Access Compliance Report

Public Rights-of-Way

(Curb Ramps)

Intersection ID: N/A	Main Street: MILLENNIUM_AV	Cross Street: POTOMAC_RIVER_PY	Location: SW
ADA ID: 3152A9634603	Ramp Type: Directional1	Initial Pass/Fail: Fail	Overall Compliance: No
Severity Score: 12.5			
Codes/Mitigation Info/Possible Solution		Field Measurements/Component Compliance

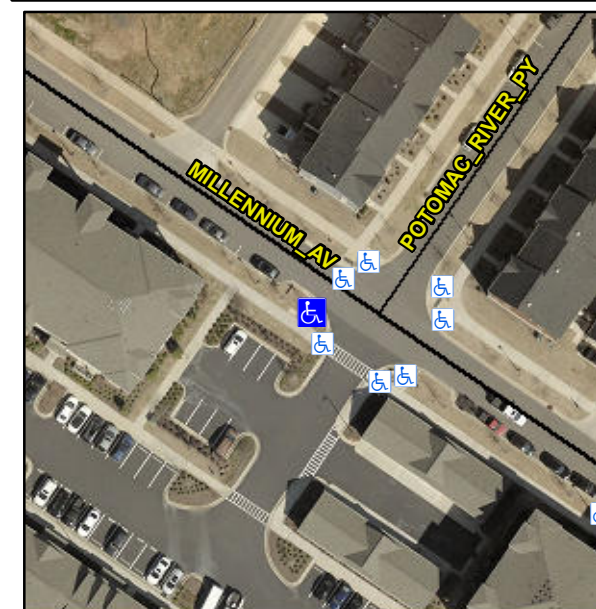
R304.2.2

Compliance	Description	Data	Compliance	Description	Data
N/A	Ramp Length (in)	115.0	N/A	Grade Break?	N/A
Yes	Ramp Width (in)	70.0	N/A	Grade Break Slope (%)	0.0
No	Ramp Slope (%)	8.8	N/A	Grade Break XSlope (%)	0.0
Yes	Ramp XSlope (%)	1.6			
N/A	Flare Type LT	N/A	N/A	Flare Type RT	N/A
N/A	Flare Slope LT (%)	N/A	N/A	Flare Slope RT (%)	0.0
N/A	Flare Traversable LT?	N/A	N/A	Flare Traversable RT?	N/A
N/A	Landing Length (in)	0.0	N/A	DWS Provided?	N/A
N/A	Landing Width (in)	0.0	N/A	DWS Contrast?	N/A
N/A	Landing Slope (%)	0.0	N/A	DWS Length (in)	N/A
N/A	Landing X Slope (%)	0.0	N/A	DWS Full Width?	N/A
N/A	Landing Curb? (Y/N)	N/A	N/A	DWS Offset LT (in)	N/A
N/A	Shared Landing?	N/A	N/A	DWS Offset RT (in)	N/A
N/A	Gutter Ponding?	0.0	N/A	Gutter Slope (%)	N/A
N/A	Gutter Lip Ht (in)	0.0	N/A	Gutter X Slope (%)	N/A
N/A	Painted X Walk1?	No		Road Slope (%)	1.0
	X Walk 1 Direction	To NE		Road X Slope (%)	0.7
	X Walk 1 Width (in)	N/A		Clear Space?	N/A

Remove & Replace Entire Ramp.
